Harrison/Police Station & Court Building – Design Guidance Review Meeting
Project Manager: Kelly Tayara & Ellen Fairleigh

Vincent Road Transfer Station – Conceptual Proposal Review Meeting
Project Manager: Kelly Tayara

Winslow Hotel (PLN50880 SPR CUP) – DRB Review & Recommendation Meeting

**CITY OF BAINBRIDGE ISLAND
DESIGN REVIEW BOARD – REGULAR MEETING
June 3, 2019**

GROUND FLOOR
Shorter (28') West Wing
Longer (6') East Wing
Additional 8' more west setback

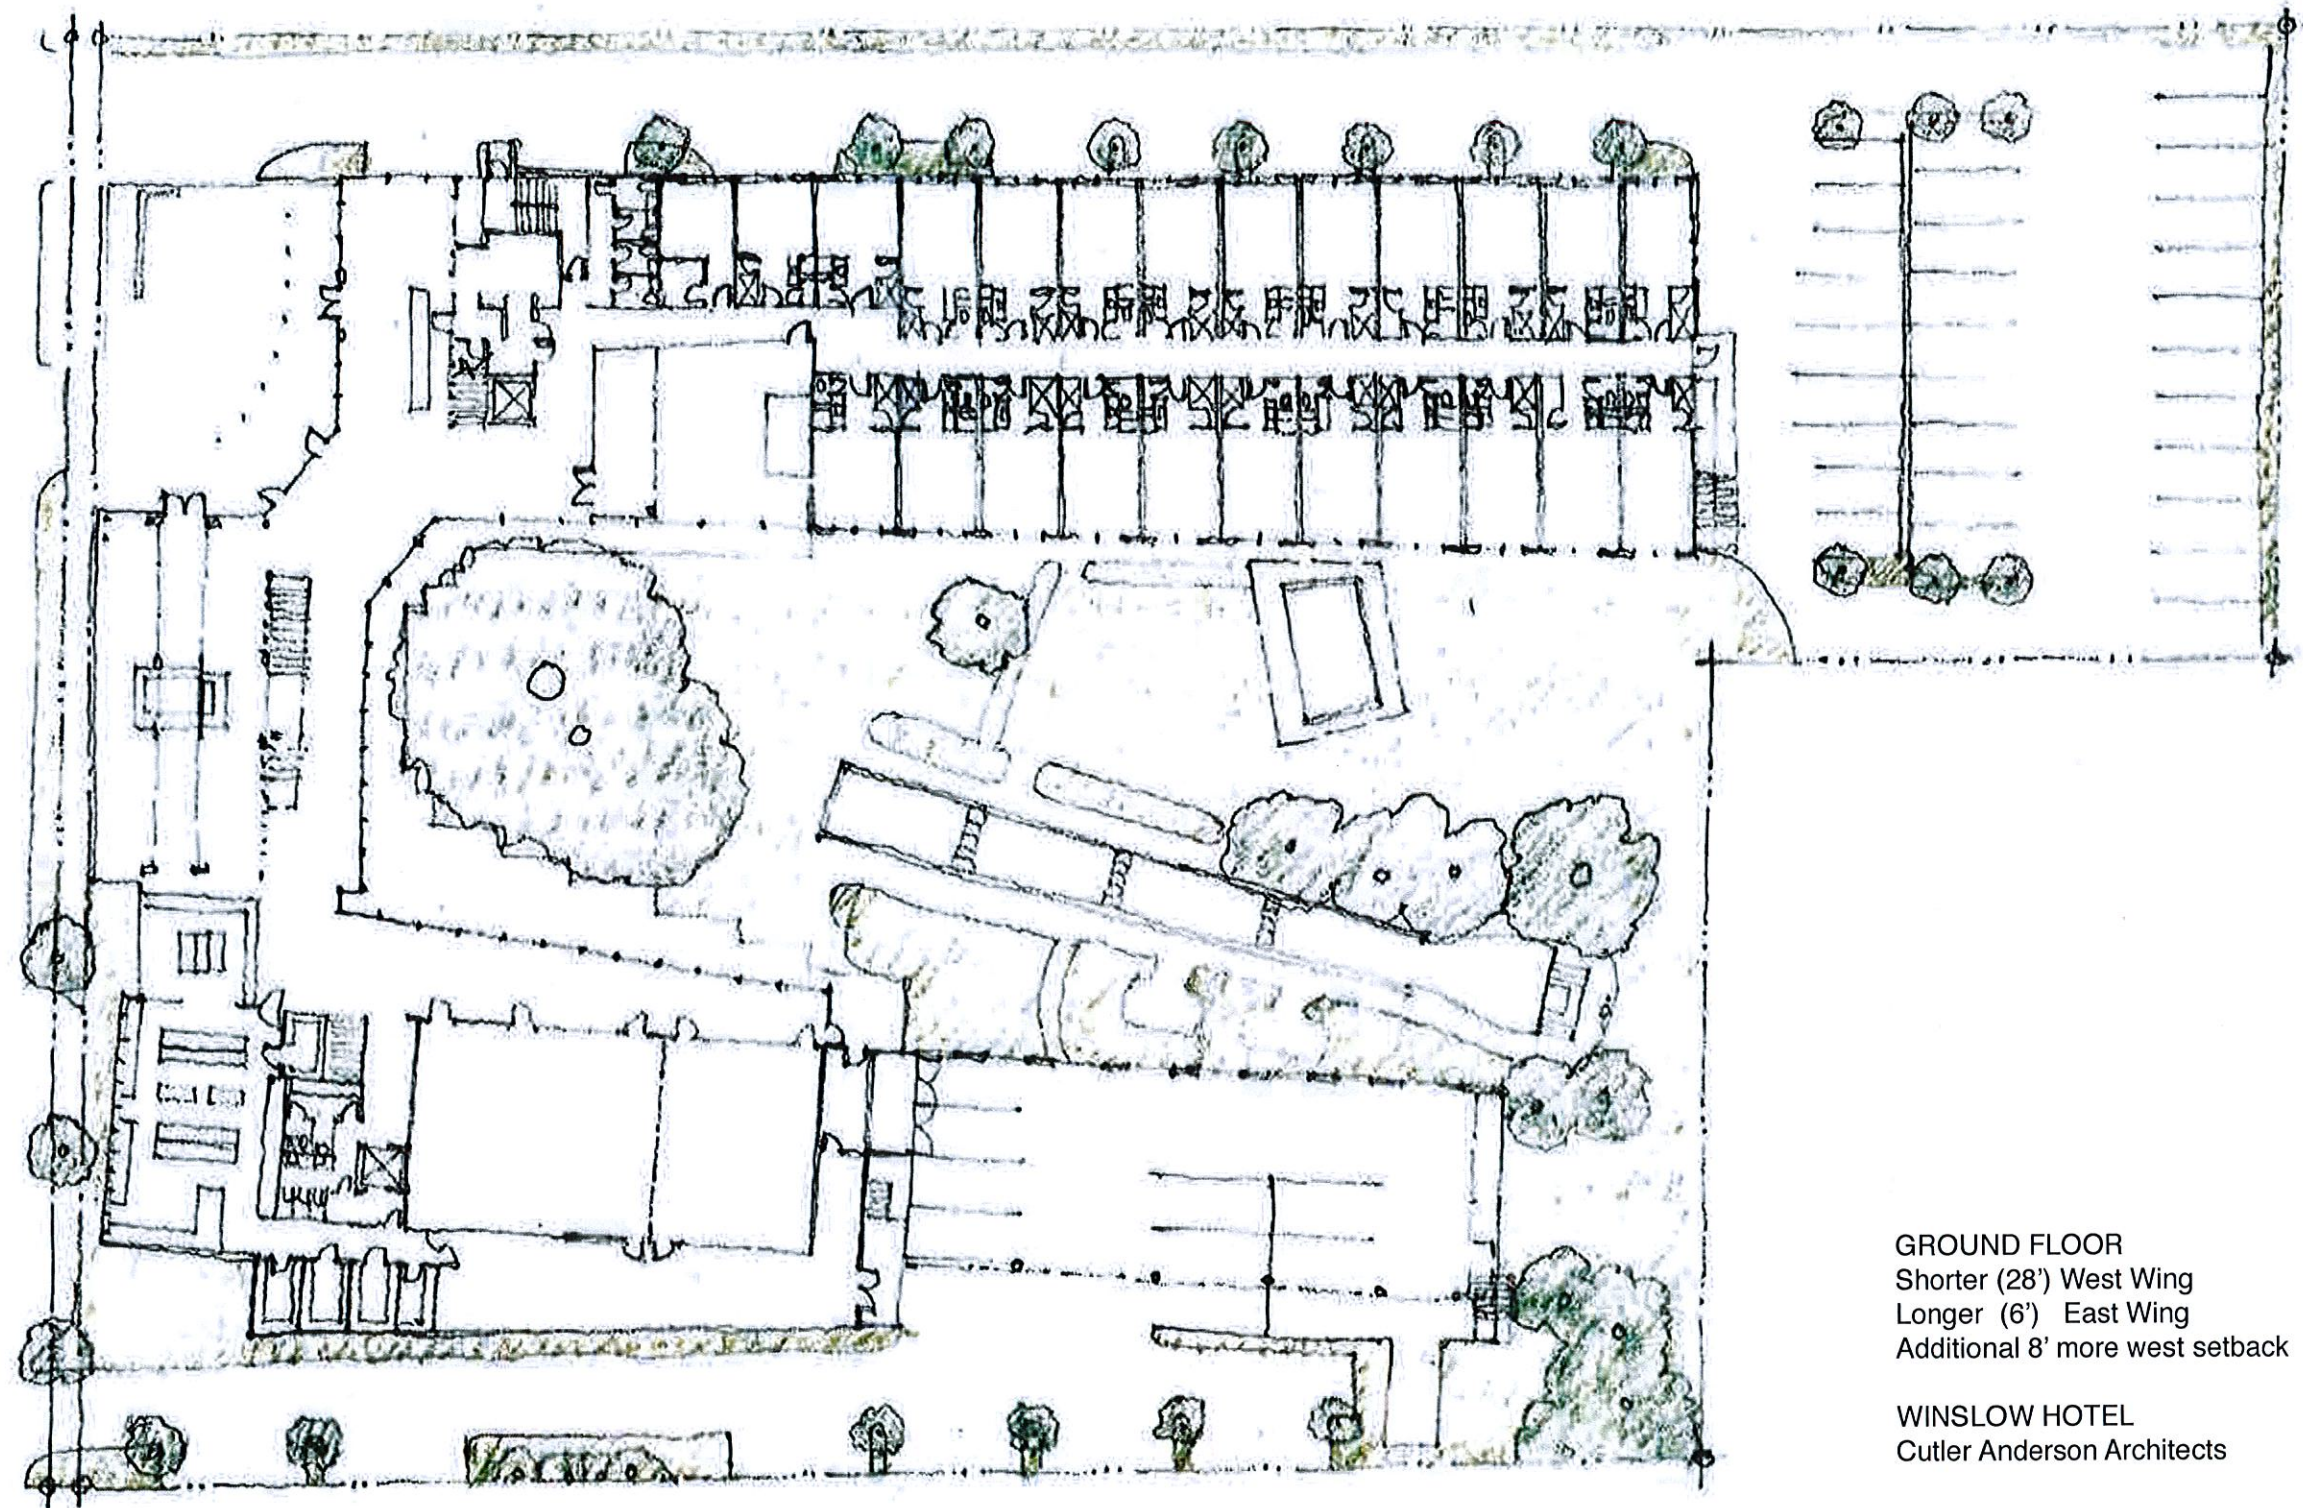
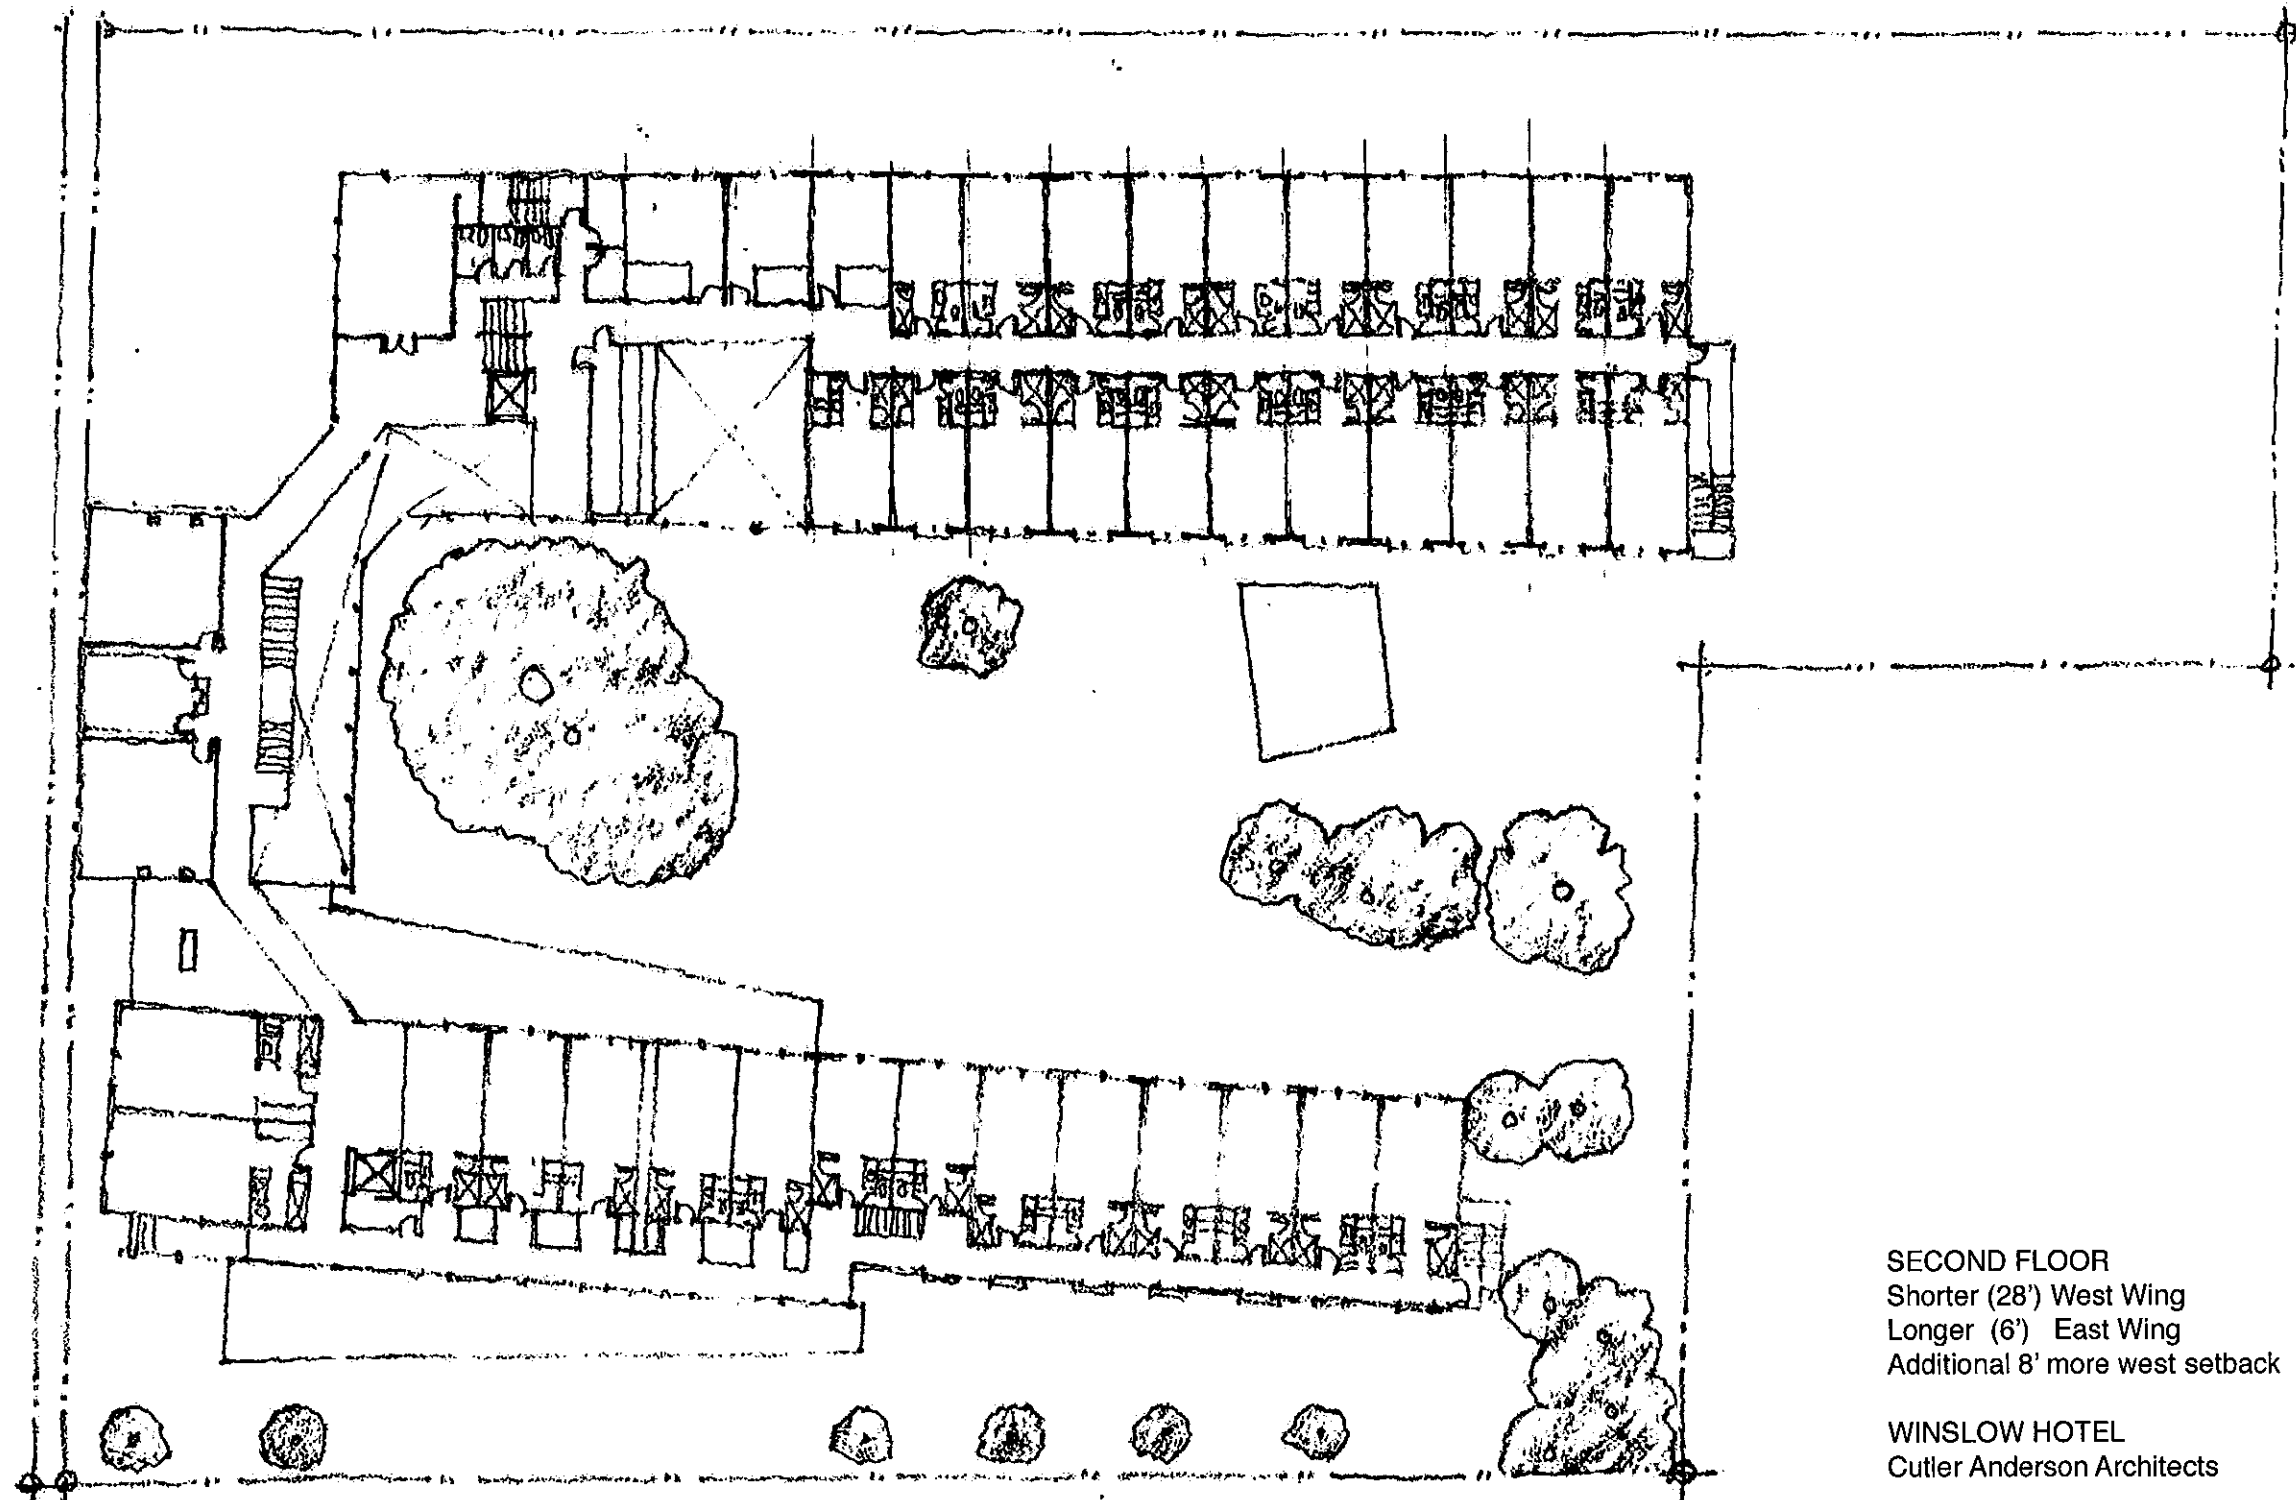
Review & Recommendation of Option 2 -

Motion: I recommend approval to move entire west wing of the façade 8 feet to the east and the addition of six parking spaces plus additional landscaping.

Dunstan/No 2nd: Passed unanimously
